Addendum #2

Project Name: Concordia STEM
Seward, NE
Project No.: 16022-05
Date Issued: May 8, 2018
Bid Date: Thursday, May 17, 2018

Date : 04/18/18
Made by : EM
Project Name : Concordia University

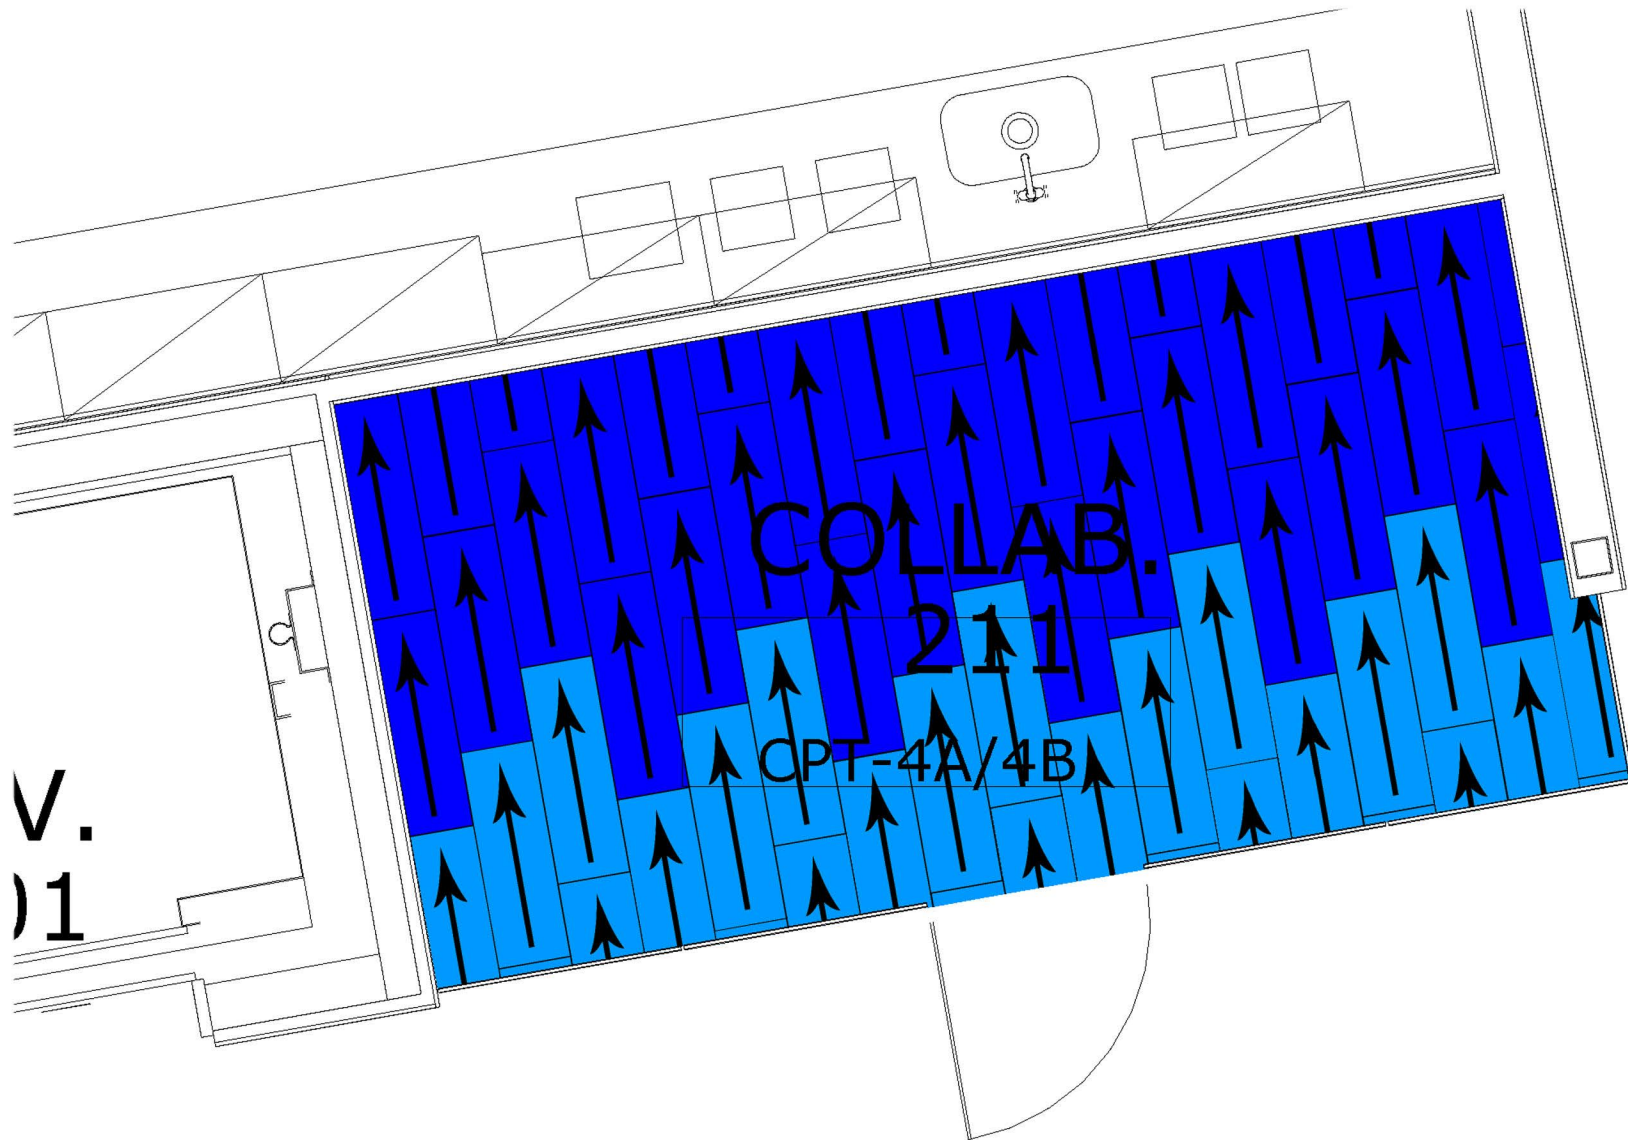
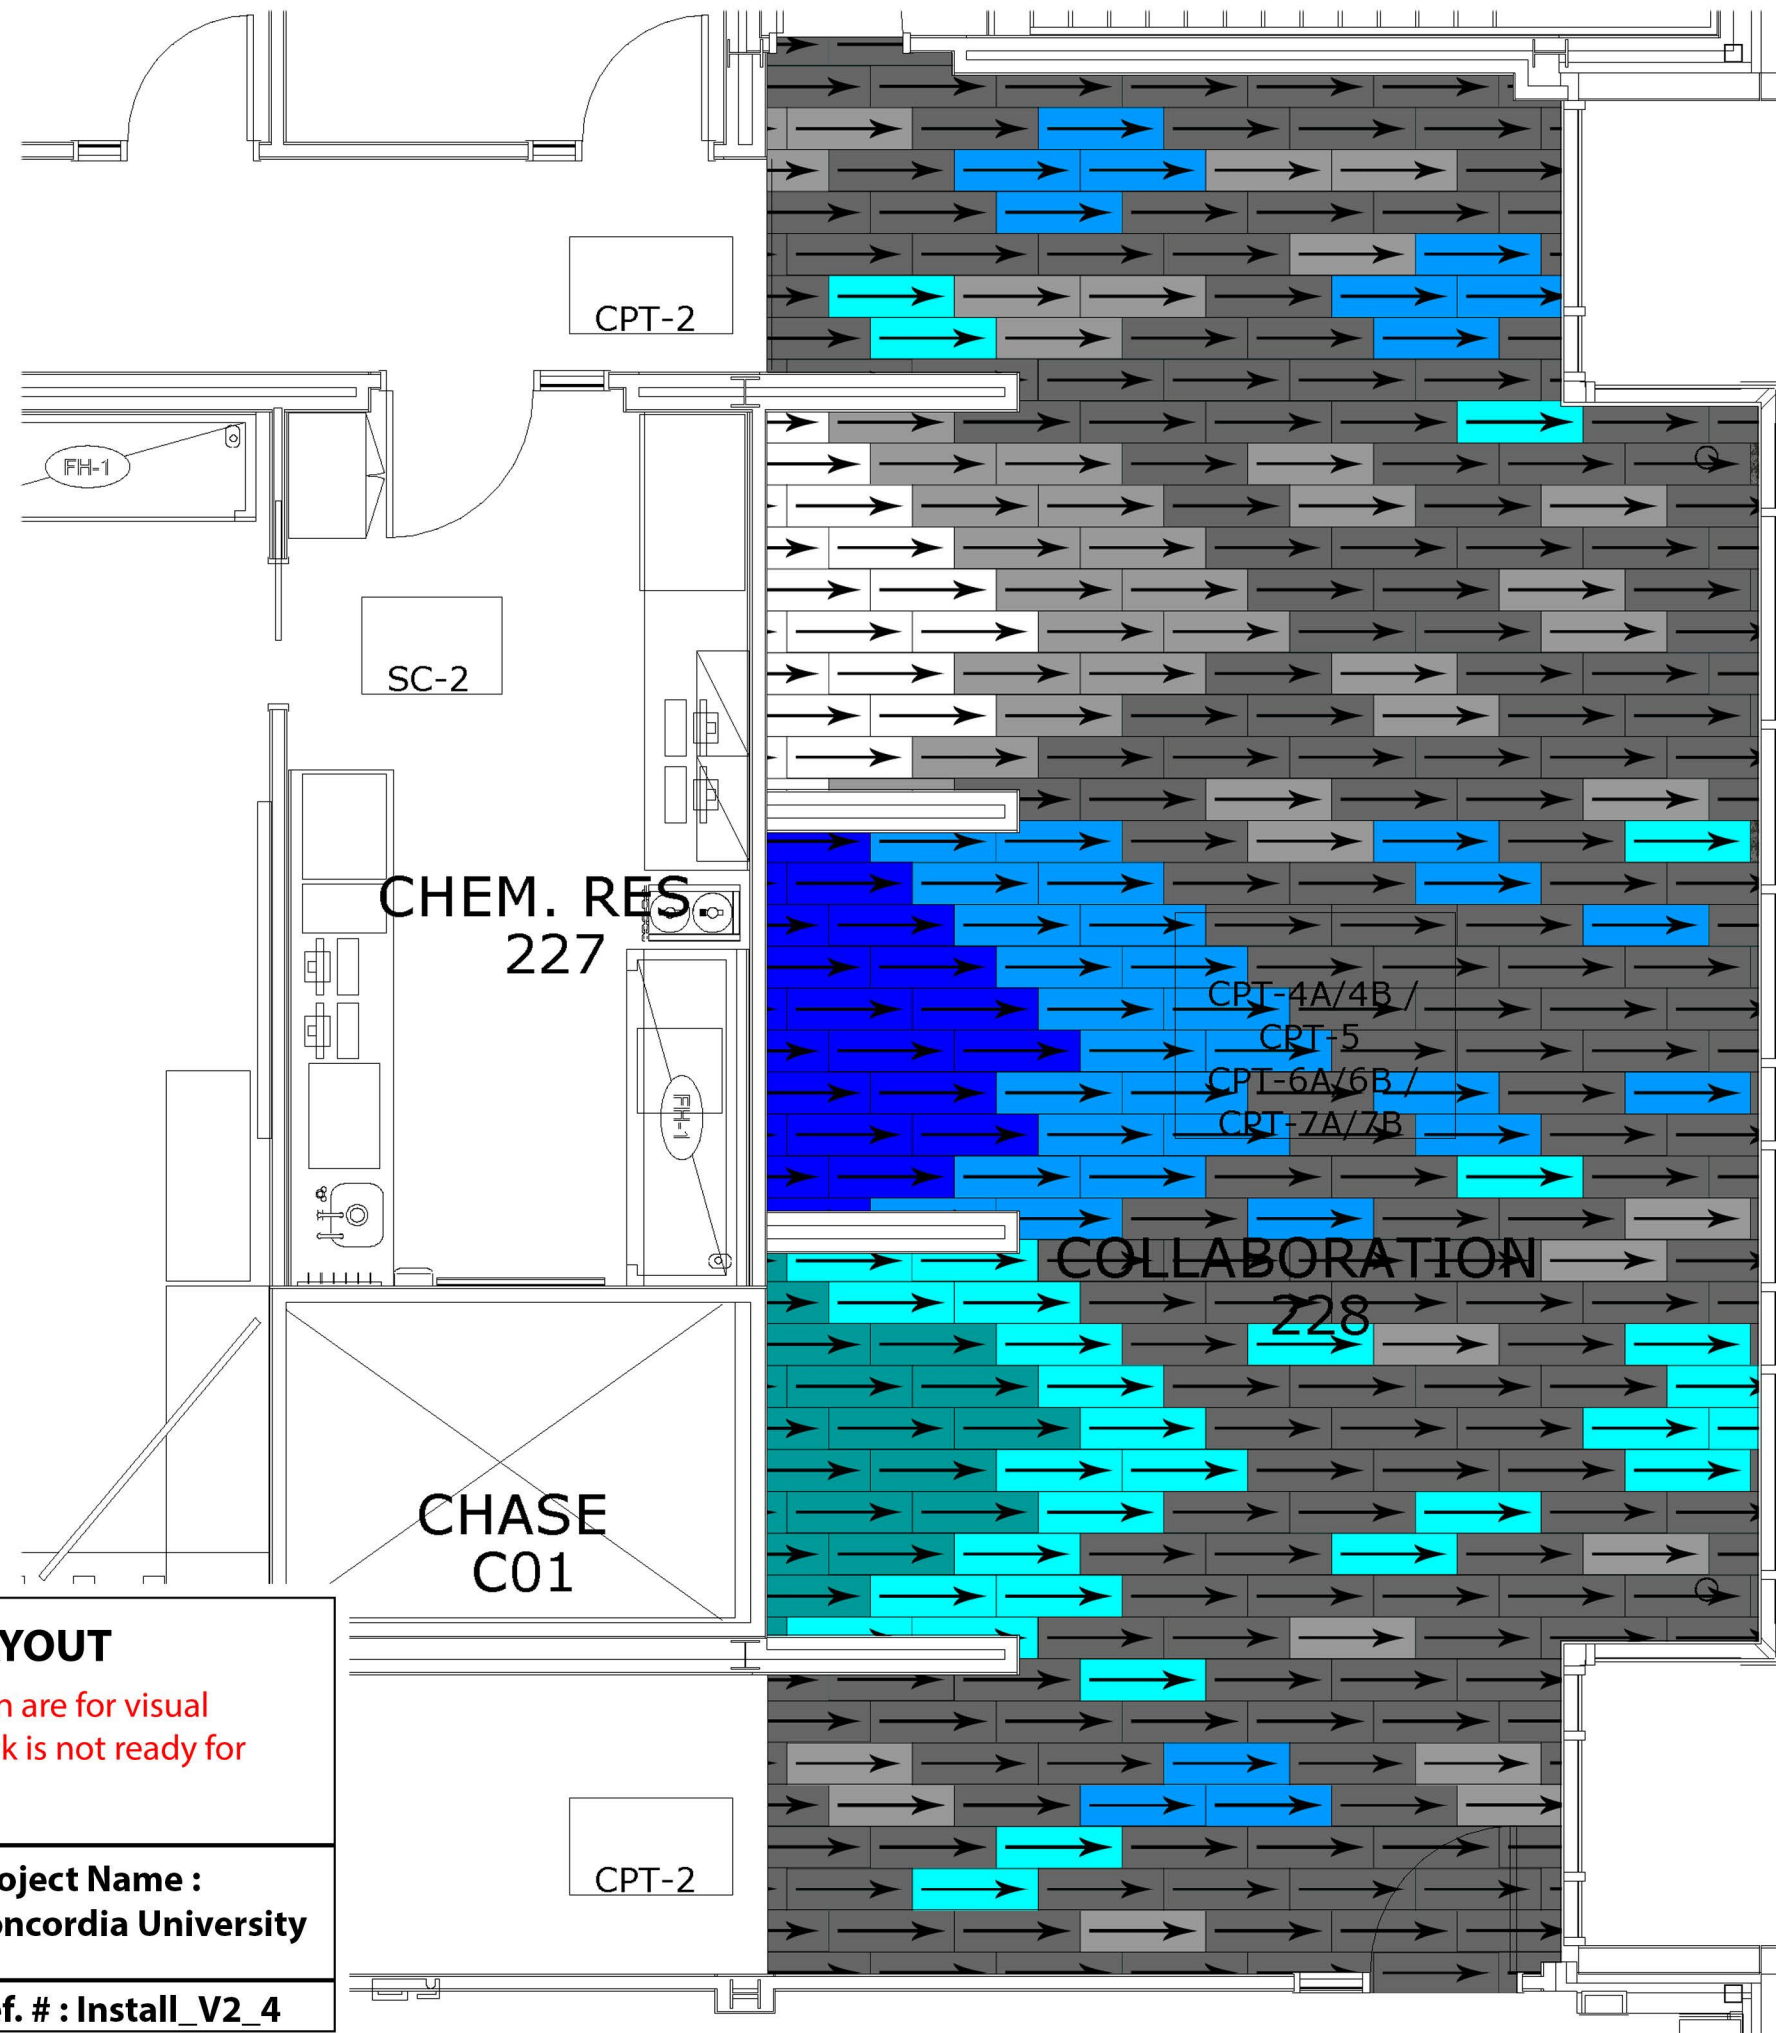
Question: *The areas of patterned carpet reference Note 4 on the plans, stating to see the manufacturer's layout included in specifications. Where is this layout with the specifications? We cannot find it for reference.*

Response: The attachments have been added to this addendum and are identified as 096813-A "Tile Carpeting Lichen Installation Layouts"

K1 INTERIOR ELEVATION

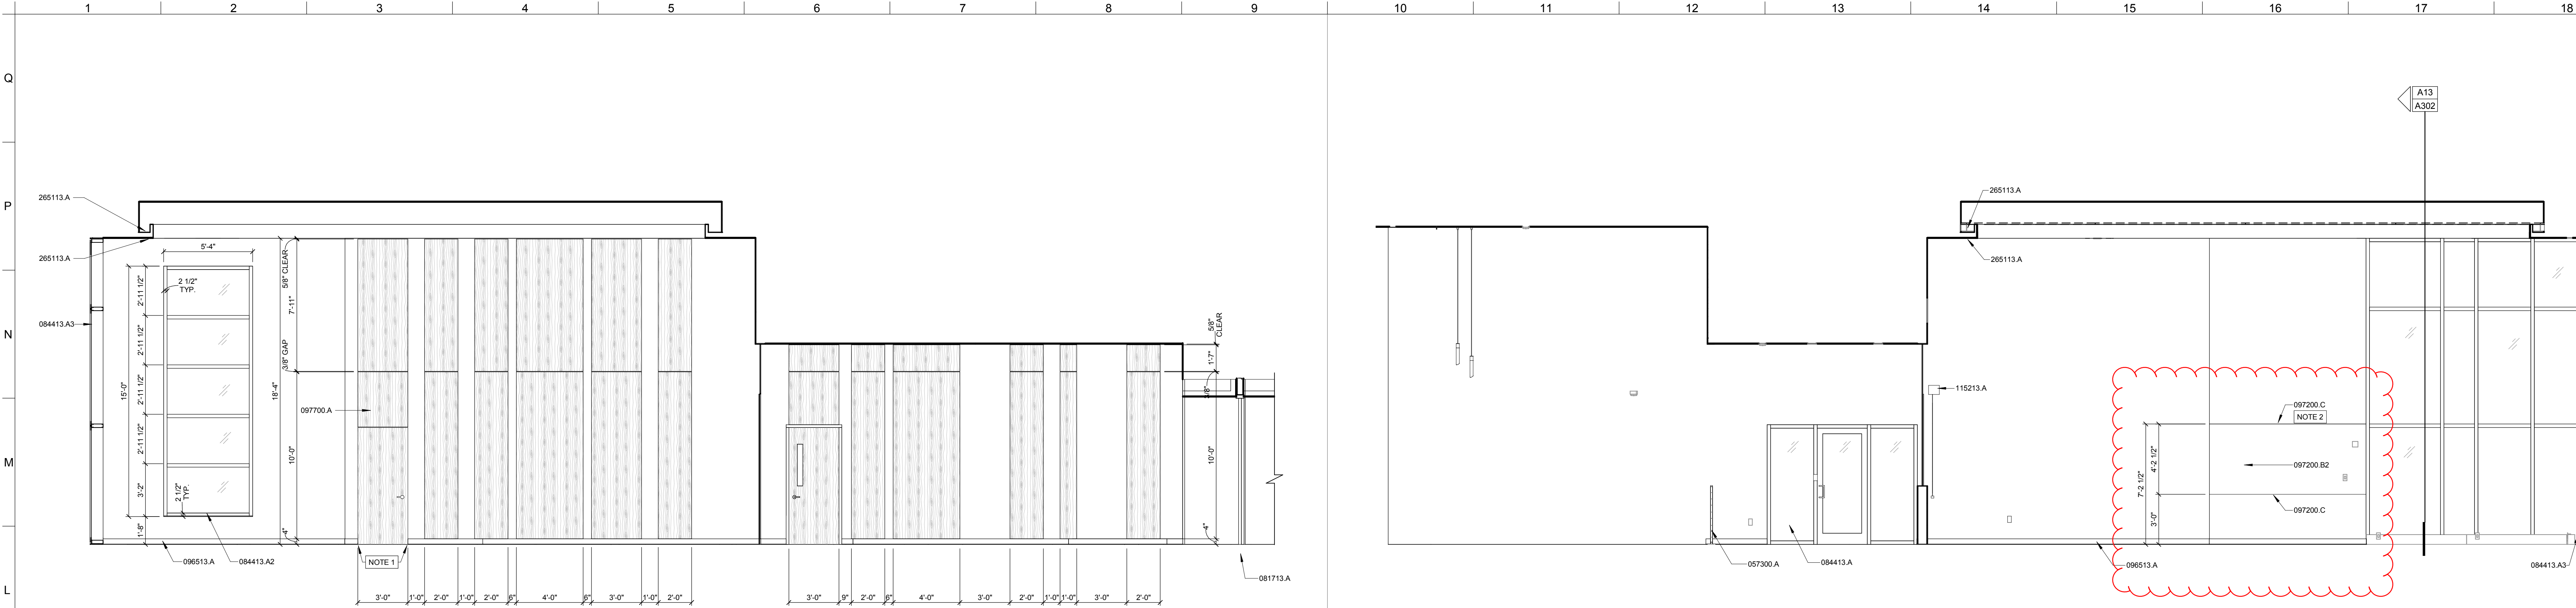
- Collaboration 202; Keynotes 097200.B2 and 097200.C have been added to the south wall.
- Prep 205; Keynote 101100.A and associated markerboard and locating dimensions have been added to the south wall.
- Genetics 212; Keynote 097200.B has been added to the north wall.
- A&P Micro 213; Keynote 097200.B has been added to the north wall.

A801B

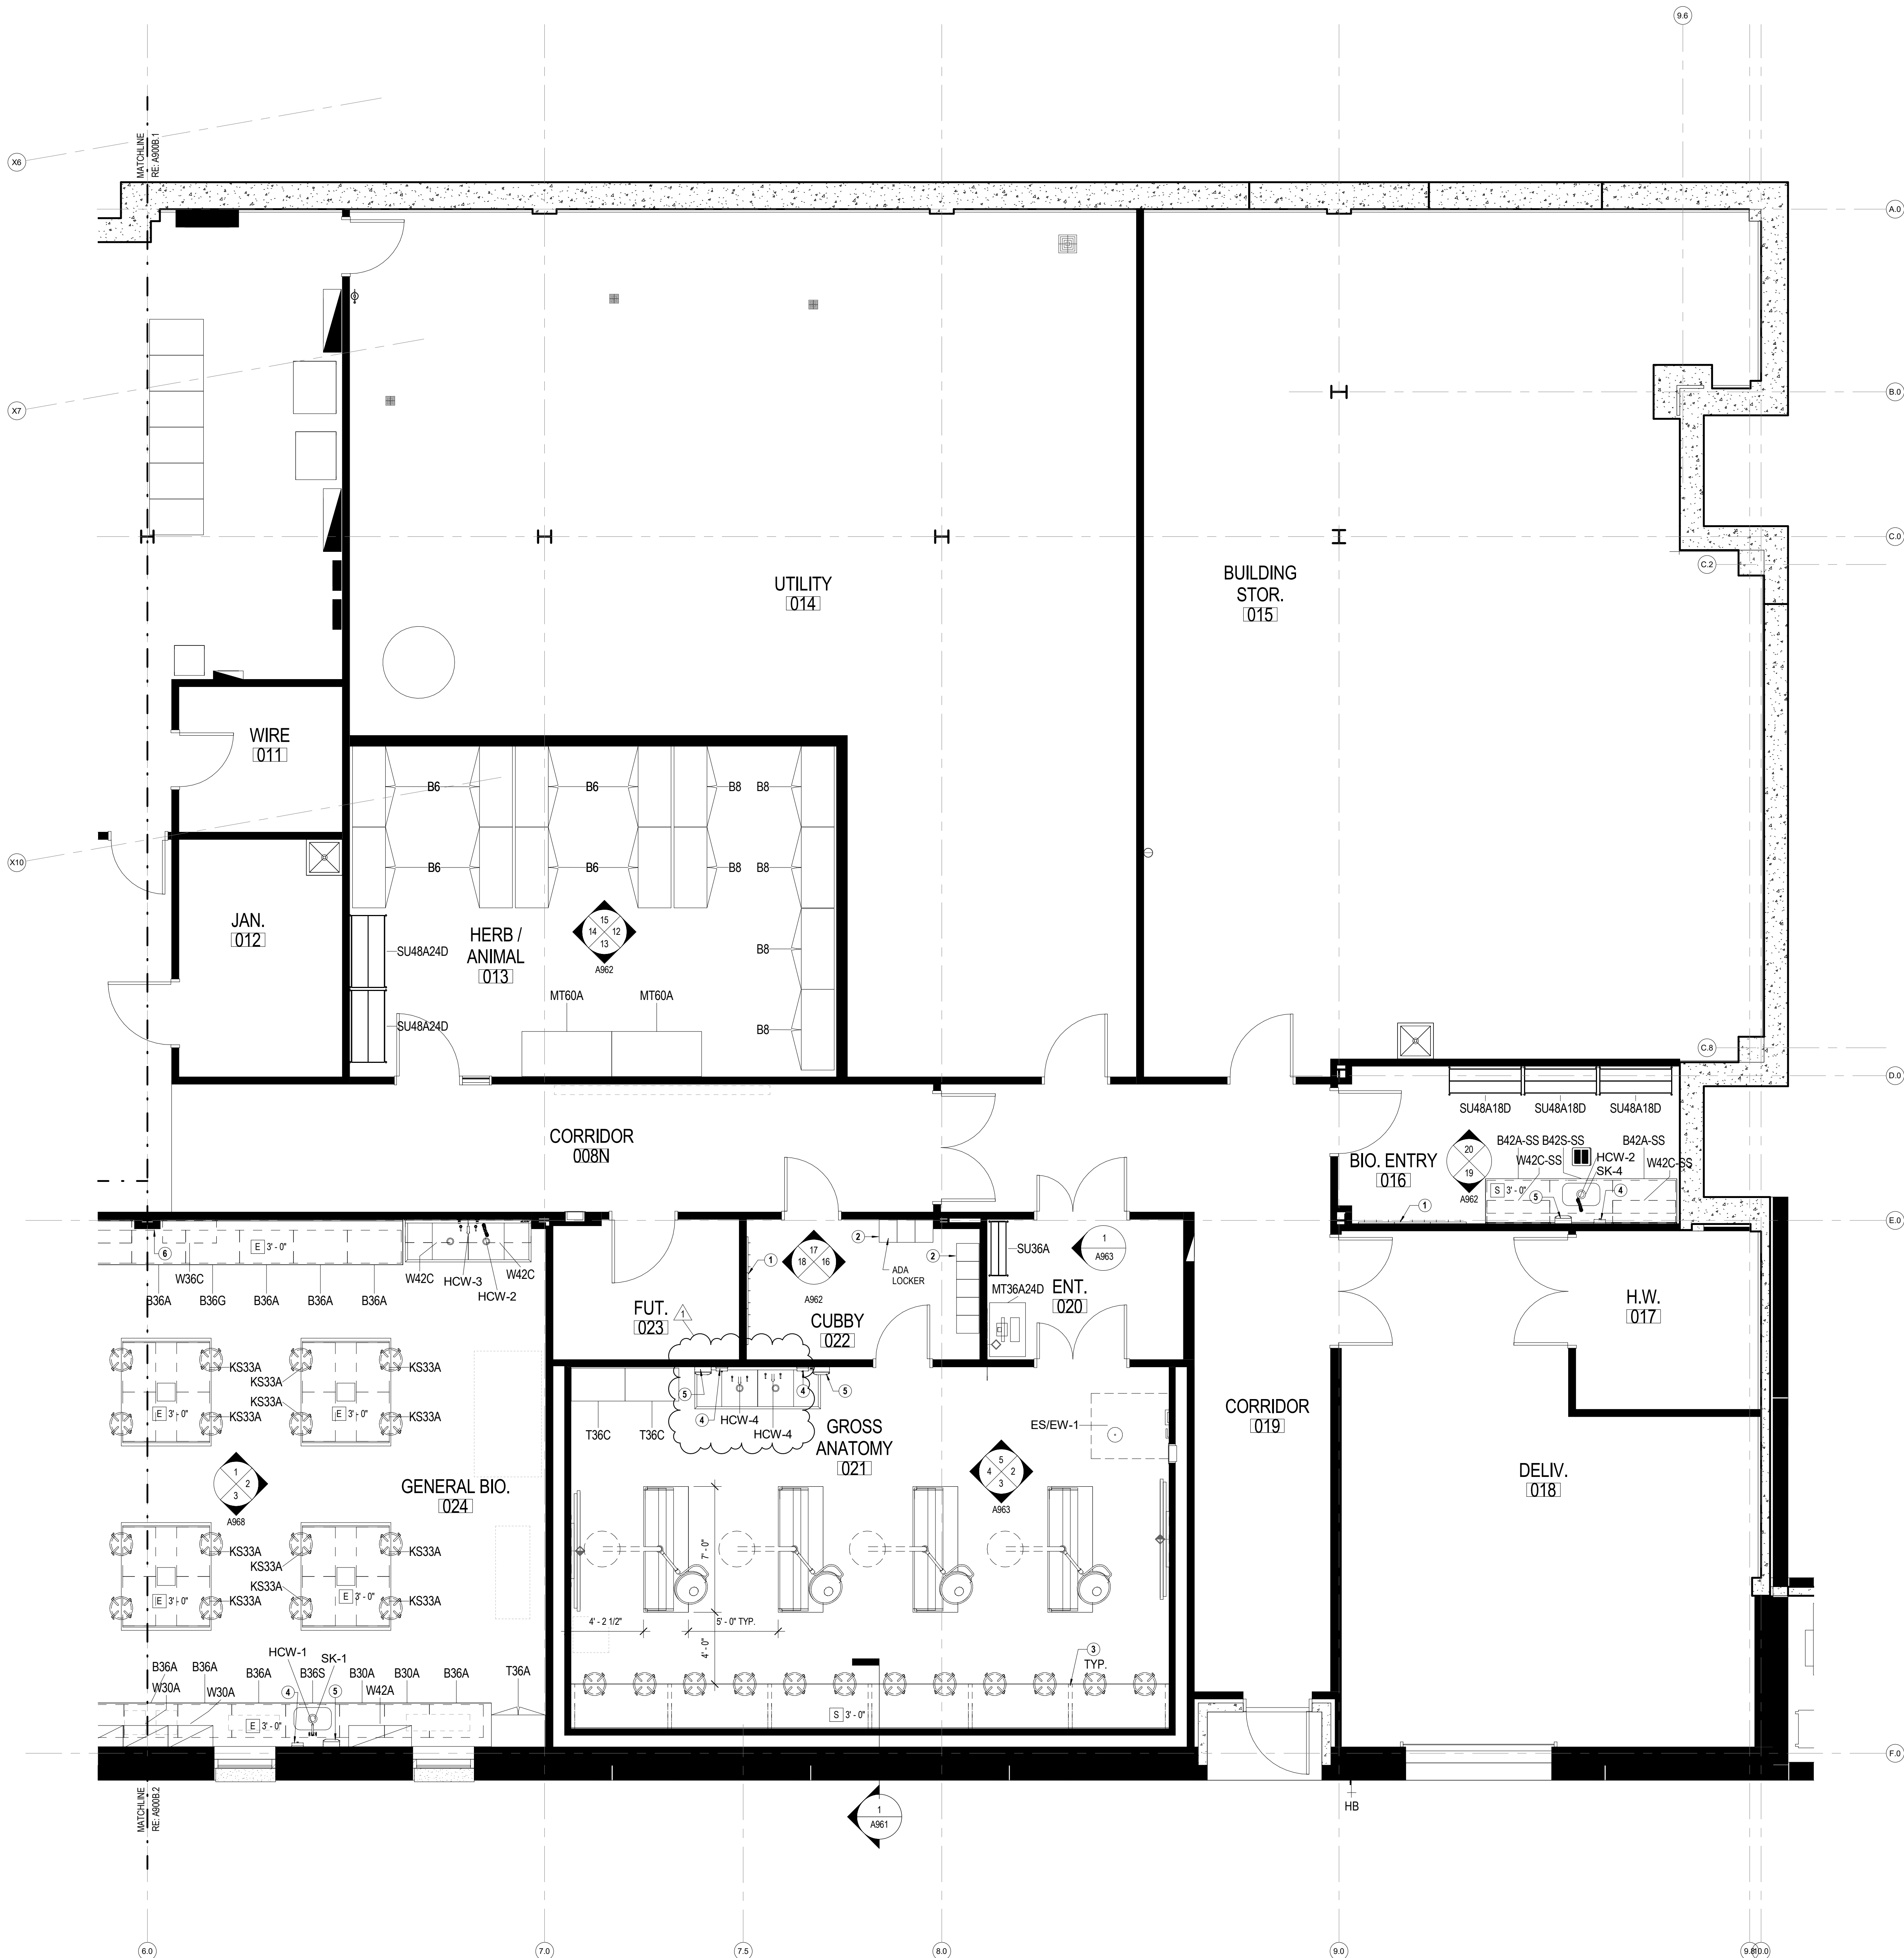
- Classroom 123; VCT-2 has been added as a finished floor surface at the north end of the room.
